Commission of Architectural Review

| 1. COA-137121-2023 | Final Review Meeting Date: 11/28/2023 |
| Project Description | Replace an existing concrete curb and stairs with brick. |
| Address: 313 North 32 nd Street | |

Figure 1. Façade, west side of 313 North 32nd Street.

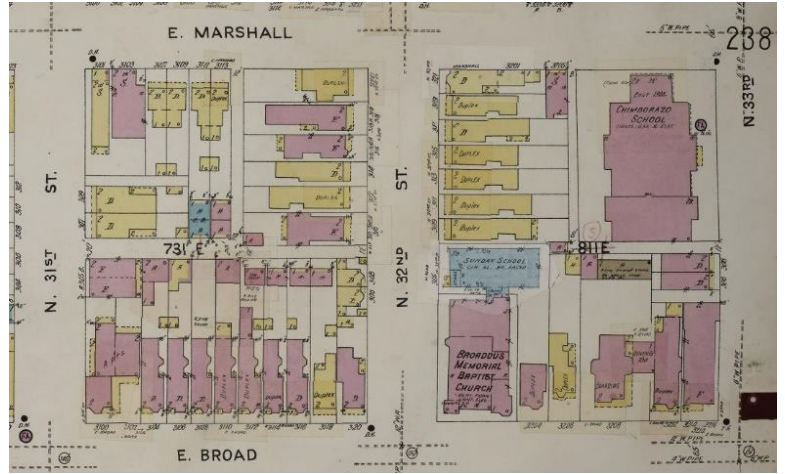
| <p>High-Level Details:</p> <ul style="list-style-type: none"> • A new duplex is being constructed at this address. • The front steps of the new house do not line up with the extant concrete steps that are built into the east side of the concrete curb of the sidewalk. • The owner of the new property plans to replace the concrete retaining wall with a small brick wall and brick steps to match the brick steps at 311 North 32nd Street. | |

| Conditions for Approval | <p>Staff recommendations</p> <ul style="list-style-type: none"> • Staff recommends approval of the request to replace and repair the existing concrete stairs and retaining wall to align with the new construction's front stairs. • Staff recommends that the concrete wall and steps be |

| | <p>realigned and repaired/replaced in-kind with concrete. New wall and steps to match the existing dimensions.</p> <ul style="list-style-type: none"> • Staff recommends denial of the request to use brick for the new retaining wall and steps. |
